MISCELLANEOUS PAPER GL-80-7

**INVESTIGATION FOR SOUTH FILL AREA
UNITED STATES MILITARY ACADEMY
WEST POINT, NEW YORK**

August 1980

Figure 16. Dissipation of excess pore pressures with time, South Fill area

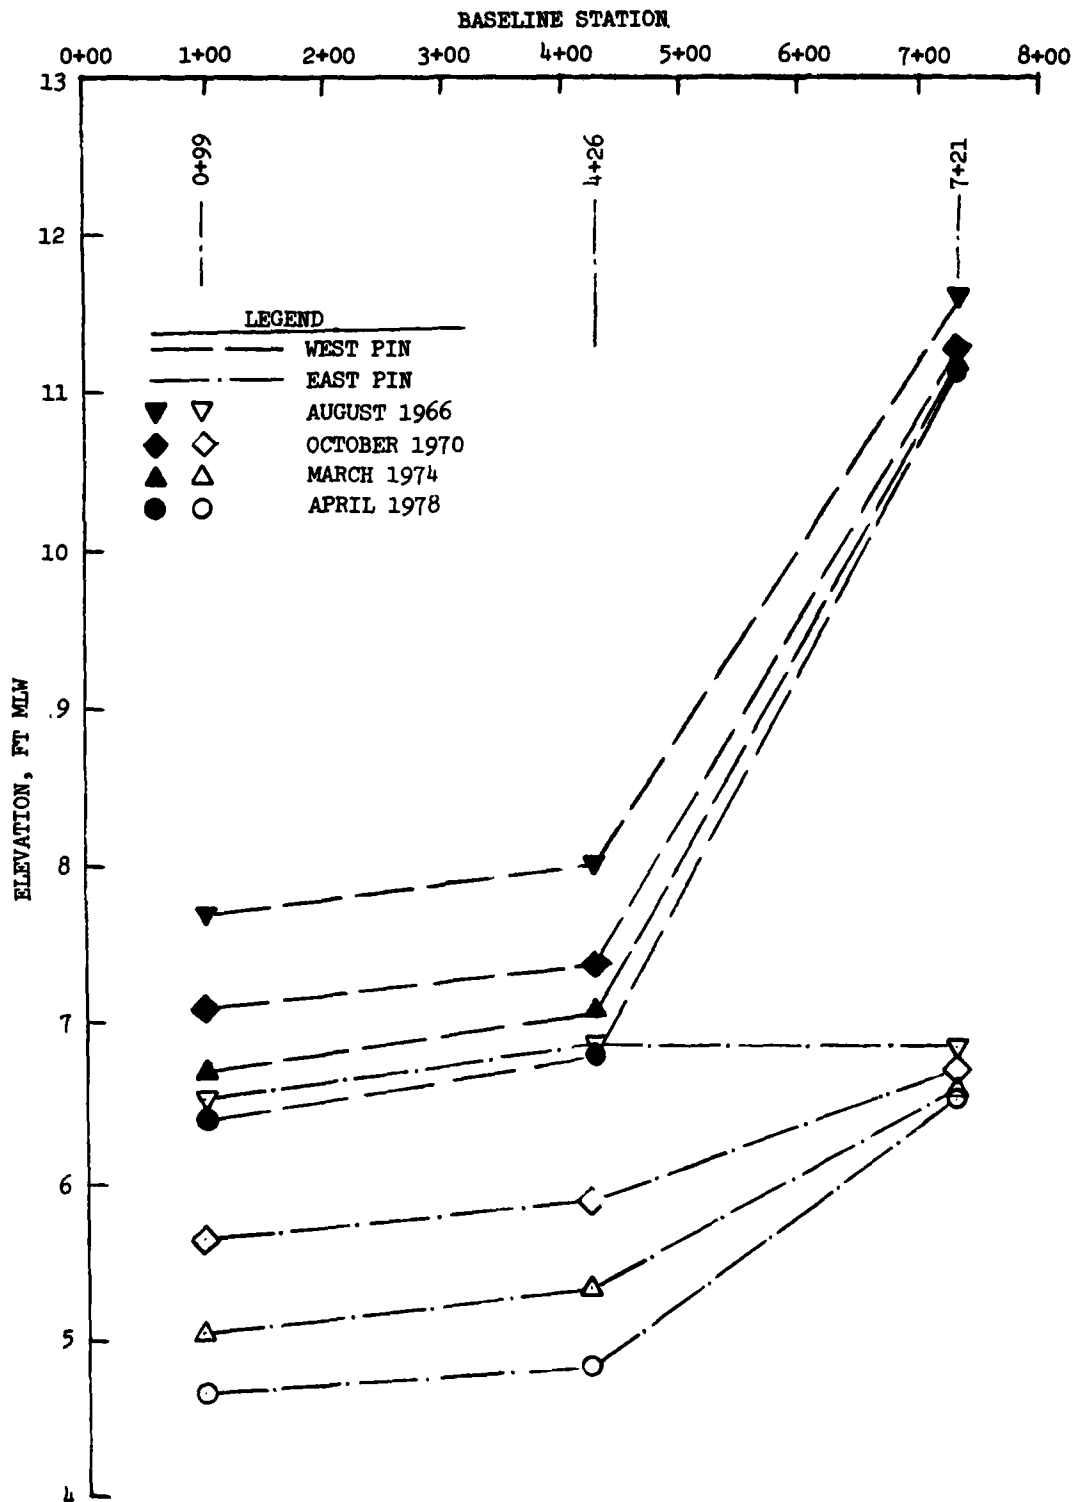
The piezometers also encountered difficulties requiring discontinuation of readings or replacements. However, enough readings have been obtained to produce an excellent plot of the dissipation of excess pore water pressures with time at one location shown on Fig. 14. The excess pore water pressures after 1973 apparently are shown only by piezometers P-7A, P-8A, P-9A and P-11. It would be helpful to the reader of this report if the specific location, depth to rock and reason for showing zero excess head of water at about Elev. -16 were stated on the figure or in the report in the section of Groundwater Conditions.
